# Southam Road, Banbury

## Stage 1 Road Safety Audit

Project Ref: 26004/2003 | Date: 19<sup>th</sup> January 2015

**SITE REFERENCE PLAN**

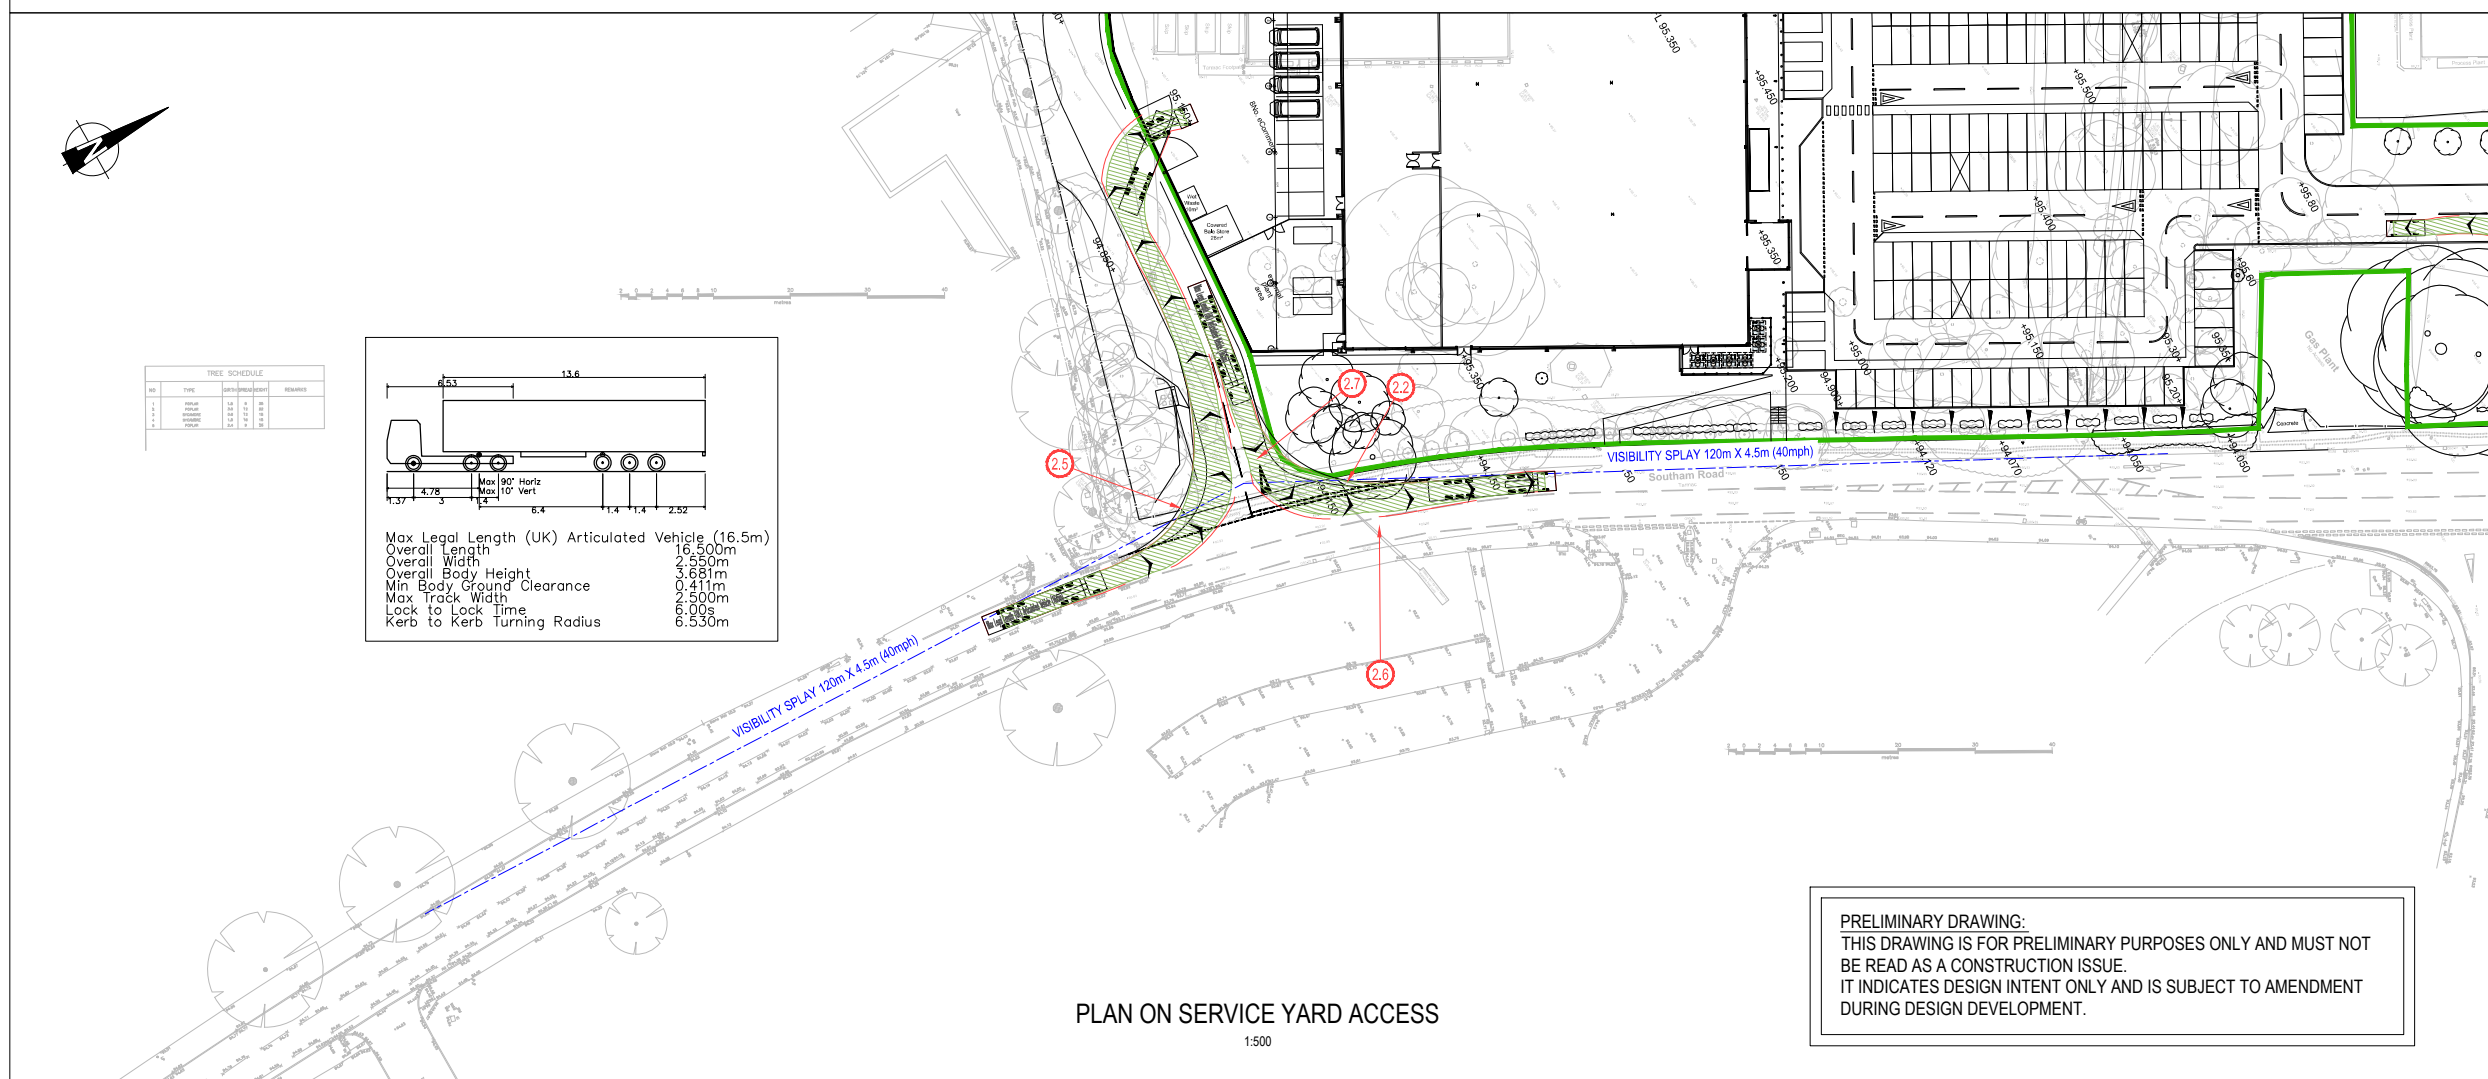
The proposed stagger distance at the Southam Road / Marley Way / Car Park Access junction is approximately 19m (**NB** Mandatory Item 7.64 of TD 42/95 states 50m as the minimum stagger distance for a ghost island junction). This reduced stagger distance may make it difficult for motorist, turning right out of the minor roads, to judge appropriate gaps in traffic flows. The presence of stationary traffic within the turning lanes could further restrict opportunities to turn right out of the minor roads. This could lead to failed to Give Way and shunt type collisions. Furthermore, the presence of the advisory cycle lane on the southbound carriageway creates the potential for cyclist to be struck by motorist manoeuvring at this junction as a result of 'looked but did not see' type collisions could increase.

The visibility splay provided to the south of the proposed Car Park junction extends across 3<sup>rd</sup> party land (Gas compound) and appears to be physically restricted by the palisade fencing surrounding the compound.

Furthermore, the junction visibility splay associated with the Service Access has not been indicated as per Fig 7.2 of TD42/95. Visibility appears to be restricted by surrounding overhanging branches.

Drawing 26004/2001/001 indicates that the right turning facility associated with the above junction is to be formed within the extent of the existing central hatching along Southam Road. However, it appears that this proposed turning lane does not have sufficient width along its entire length to accommodate the width of all vehicles using this turning facility. This design may mislead some motorists into thinking that all right turning vehicles can manoeuvre into the turning lane and completely clear the through lane. This would not be the case for larger vehicles, potentially resulting in shunt type collisions. Furthermore, through traffic, obstructed by stationary / slowing turning vehicles, could be forced into making a late manoeuvre, swerve into the adjacent advisory cycle lane, potentially colliding with a cyclist.

Further to Problem 2.3, the width of the existing advisory cycle lane is only 1m wide. The effective width of this narrow facility is further reduced by the gully grates adjacent to the kerbline. This reduced width may lead to collisions between cyclist and other road users. Item 7.4.2 of Local Transport Note 2/08 – 'Cycle Infrastructure Design' states "*Cycle lanes should be 2m wide on busy roads, or where traffic is travelling in excess of 40mph.*"

The layout of both junctions does not include tactile paving at the crossing points. Furthermore, these crossing points (including the existing crossing point across Marley Way) have been located on the direct desire line across the bellmouths of the minor arms. Due to the corner radii of these junctions, this requires visually and mobility impaired pedestrians to cross the widest section of the carriageway, increasing the risk of being hit by another road user.

The introduction of a supermarket on the western side of Southam Road creates a new trip generator for NMUs. However, the proposed scheme drawing does not provide any facilities to cater for the likely increase in pedestrians and cyclists wanting to cross Southam Road (it is noted that the Audit Brief makes reference to proposed crossing facilities). During the site visit, the Audit Team noted that it was difficult to crossing Southam Road due to a continuous flow of traffic. The lack of crossing facilities could result in an NMU being struck by other road users.

- Not all vehicular movements have been reviewed at either of the proposed junctions;
- The design vehicle used to analysis the Car Park access is not the more onerous vehicle type that could use this junction (refer to Problem 2.3);
- The analysis of the HGV turning left out of the Service Access has been undertaken with the starting point of the design vehicle on an unrealistic alignment;
- The speed at which these manoeuvres are being undertaken has not been stated;

The drawing submitted for Audit review indicates proposed levels for the new car park access road. However, these levels are approximately 2m above the existing road levels. It is assumed that this is a drafting error.

In the absence of a Transport Assessment, the Audit Team would recommend altering the proposed form of the Southam Road / Marley Way / Car Park Access junction from a staggered junction, to a roundabout or signalised junction.

Full and unrestricted junction visibility splays should be provided within the extent of the adopted highway boundary for this 40mph road. These visibility splay should be safeguarded by undertaking any necessary vegetation reduction / removal of overhanging branches.

The width of the turning facility should be increased in order to comply with the requirements stated within Mandatory Item 7.35 of TD 42/05 for this new junction.

The Audit Team recommend that this facility is increased in width. Gully grates could be replaced with kerb outlets (associated gully pots relocated).

Road markings, including Diag 1057 (cycle symbol) should be reapplied. A coloured surface should be provided across the Southam Road / Marley Way junction to help increase the conspicuity of this facility and increase driver awareness of cyclist as per 7.3.2 of LTN 2/08.

Uncontrolled crossing points should be provided inset into the minor roads. If possible, the corner radii forming the junctions should be reduced in order to locate these crossing points closer to the direct NMU desire line.

An assessment (such as LTN 1/95 – ‘The Assessment of Pedestrian Crossings’) should be undertaken to determine the need and appropriate form of crossing facilities required across Southam Road. Following this assessment, the proposed junctions should be amended to accommodate the outcome of this assessment if necessary. Any proposed crossing provisions should consider and accommodate the existing bus stops located to the north of the proposed Car Park junction, as well as the Public Right of Way on the south side of the proposed Service Access.

The swept path analysis should be repeated in response to the above in order to confirm that the proposed layout is suitable with any subsequent alterations to the design undertaken as necessary to ensure vehicles do not strike kerbs, overhang potential off carriageway NMU provisions, etc.

This assumed draft error should be corrected.
